Reference: 2024-007M

URGENT - FIELD SAFETY NOTICE

To user of **Olympus Evis Exera III Gastrointestinal Videoscope**

Re: Olympus to Provide New Reprocessing Instructions for GIF-1TH190.

4. (1st port) Hold the control section, and aerate the suction cylinder, as follows:

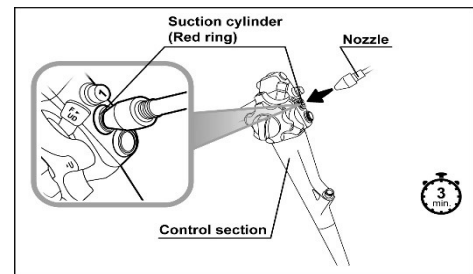
- a) Start the timer. (3 minutes)
- b) Push the nozzle straight into the suction cylinder and blow.
- c) Keep blowing until the timer alarm beeps.

5. (2nd port) Hold the control section, and aerate the air/water cylinder, as follows:

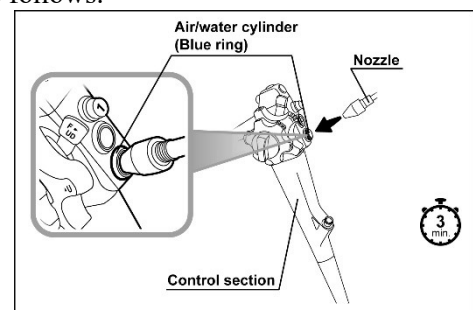
- a) Start the timer. (3 minutes)
- b) Push the nozzle straight into the air/water cylinder and blow.
- c) Keep blowing until the timer alarm beeps.

6. (3rd port) Hold the endoscope connector, and aerate the auxiliary water inlet, as follows:

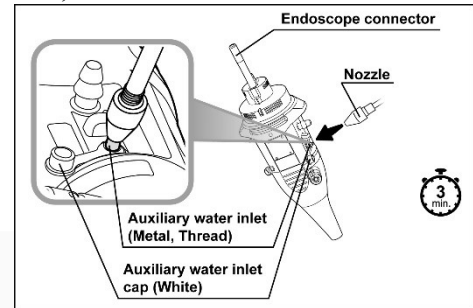
- Start the timer. (3 minutes)
- Push the nozzle tip straight into the auxiliary water inlet to minimize air leaks and blow air.
- Keep blowing until the timer alarm beeps.

7. (4th port) Hold the control section, and aerate the instrument channel port, as follows:

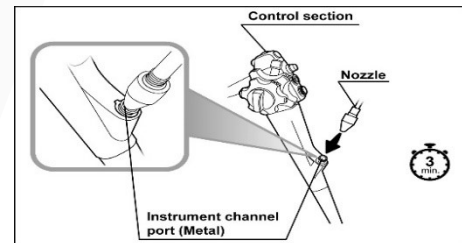
- Start the timer. (3 minutes)
- Push the nozzle straight into the instrument channel port and blow.
- Keep blowing until the timer alarm beeps.
